Mr Robert Walker  
Senior Development Assessment Officer  
Penrith City Council  
601 High Street  
Penrith, NSW, 2751

**RE: DA22/01080 – RFI dated 15 March 2023**

## **93 Lockwood Road Erskine Park Warehouse and Distribution Centre**

## **Annexure C – Cabbage Tree Carpark Canopy Assessment Plan**

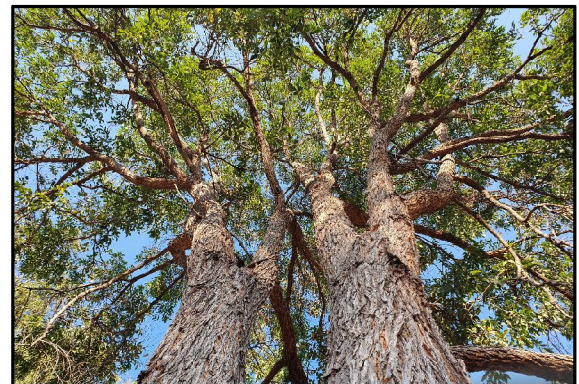
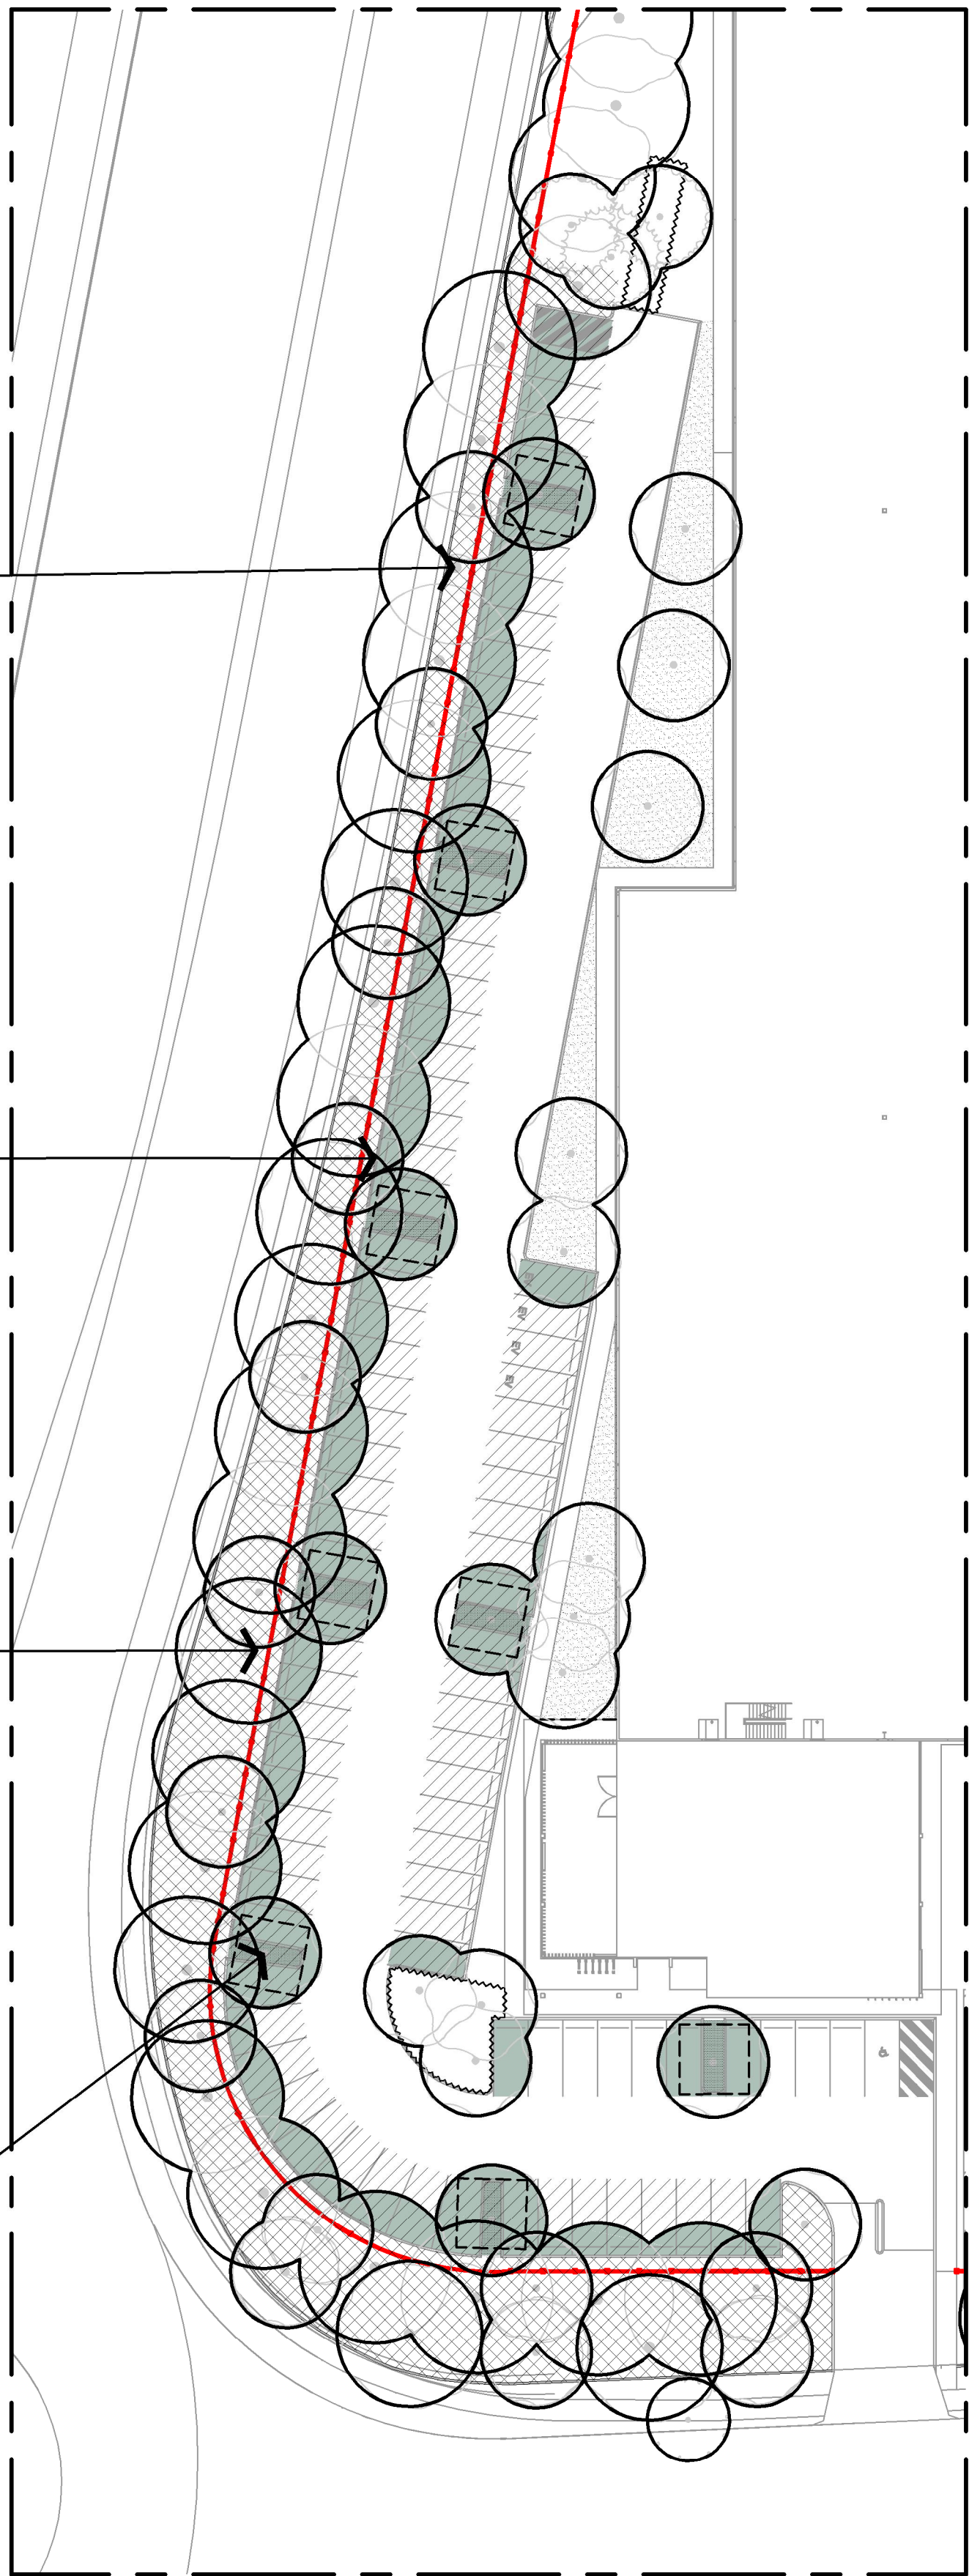
| <p>e) The overall layout provides inadequate setbacks, and does not provide sufficient landscaping to screen the built form and integrate the development into the existing streetscape. The proposed landscaping scheme fails to provide any shade trees within the proposed car parking areas, which is inconsistent with Part C6.1.3 (C3) of the Penrith DCP, whereby one (1) large shade tree is to be provided for every six (6) car spaces. It is requested that amendments be made to the overall layout to provide shade trees within the car parking areas, in accordance with the requirements of Part C6.1.3 of the Penrith DCP.</p>                                                                                                                                               | <p>The landscape setback is exceeded on balance as demonstrated in the annexed Nettleton Tribe drawing SK12 (B) (Annexure B) and will provide sufficient landscaping to screen the building as demonstrated by the photos of other buildings within our Estate, the Auto Nexus facility and the Flower Power facility, from Lenore Drive (Annexure F). We have modified the drawings to include blister islands in the carpark at a rate of 1 for every 10 spaces as approved in our last application. The cost of engineered vaults is excessive and we looked to exclude them because we had already met the 40% canopy cover requirement, however, we have now incorporated the blister islands in the annexed Cabbage Tree drawing L607 DA_02A of the JAN 2023 (Annexure C). The carparking area is 1,386sqm and the canopy provided is 712sqm or 51%.</p> |

| i) The proposed landscaping scheme is inconsistent with Part C14.2.1.4 of the Penrith DCP, which requires open car parking areas to be provided with a minimum 40% tree canopy cover. It is requested that amendments be made to the proposed landscaping scheme which provides tree canopy cover over associated car parking areas, in accordance with the requirements of Part C14.2.1.4 of the Penrith DCP. Furthermore, the application does not demonstrate the provision of adequate soil volumes for tree planting areas, as required by Part C14.2.1.3 of the Penrith DCP. Accordingly, it is requested that details be provided demonstrating compliance with the soil volume requirements of Part C14.2.1.3 of the Penrith DCP. | As demonstrated in Annexure C, 51% tree canopy cover is provided with blister islands. We have modified the plans to include blister islands as requested at significant expense. Landscaping plans will be modified to demonstrate soil volume requirements.                                                                                                                                                                                                                              |
